DEVIATION REQUEST AND DECISION FORM

Project Name : Saddlehorn Ranch – Filing 2
Schedule No.(s) : 4300000602
Legal Description : SEE ATTACHED – Exhibit C

A deviation from the standards of or in Section **ECM section 4.3.6.3 Underground Utilities Standards** of the Engineering Criteria Manual (ECM) is requested for the culverts in Saddlehorn Filing 2.

SADDLEHORN RANCH – FILING 2 CULVERT VARIANCE EXHIBIT	1"=200'	No.	REVISION	BY	DATE
	H-SCALE V-SCALE DATE DESIGNED BY DRAWN BY CHECKED BY	1"=200' N/A 5/1/24 AAM AAM AAM			
SHEET 1 OF 1	JOB NO. 25142.04

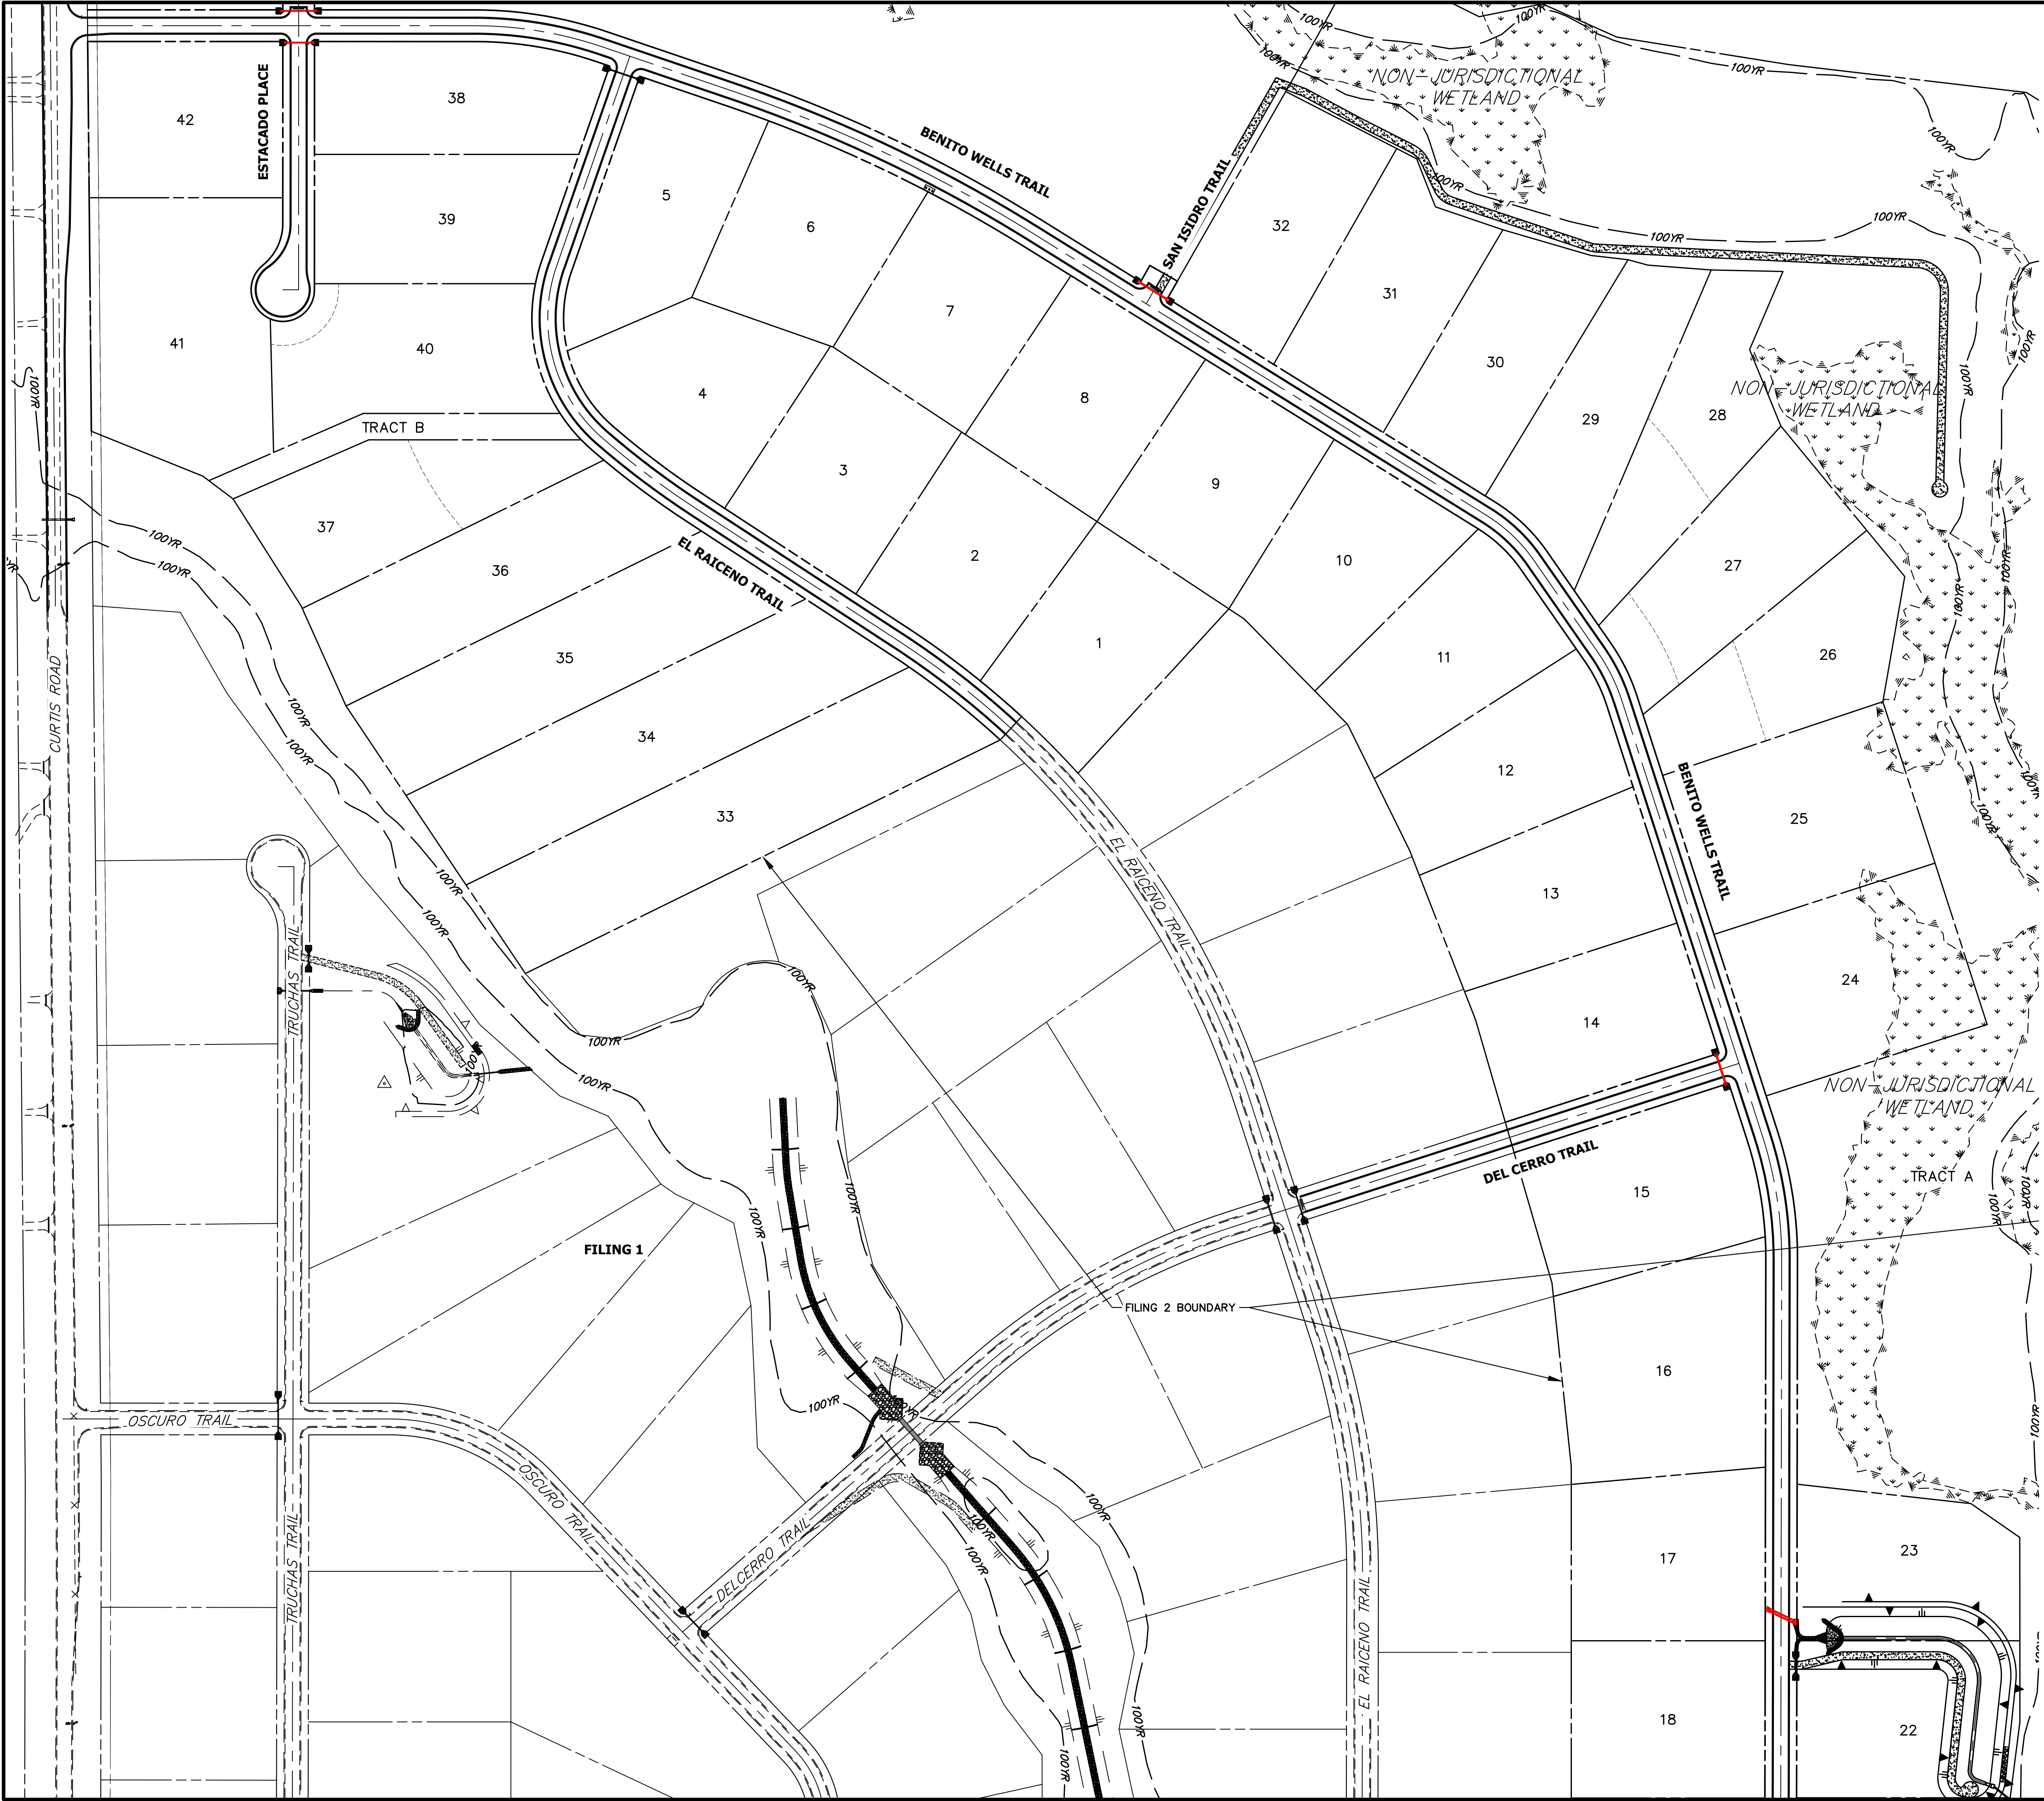
Criteria for cover of storm sewer lines per the ECM, shall be no less than 2 feet. The following request will be to deviate from this minimum, and instead request to utilize CDOT Standard M-603-2.

For storm sewer design, a minimum cover of 2 feet is required, per 4.3.6.3 of the ECM. This deviation proposes a reduction of this cover, and instead utilize CDOT's M-603-2 standard for culvert design. This CDOT standard allows a minimum of 1' of cover from the top of the pipe, and includes the pavement thickness. The AASHTO LRFD tables, using an HS-20 live load, were also used to check the Class III concrete pipe strength at each fill height. This will ensure the culverts have adequate strength at the reduced cover. A total of 5 culvert crossings will be impacted by this deviation. See Exhibit C for culvert locations.
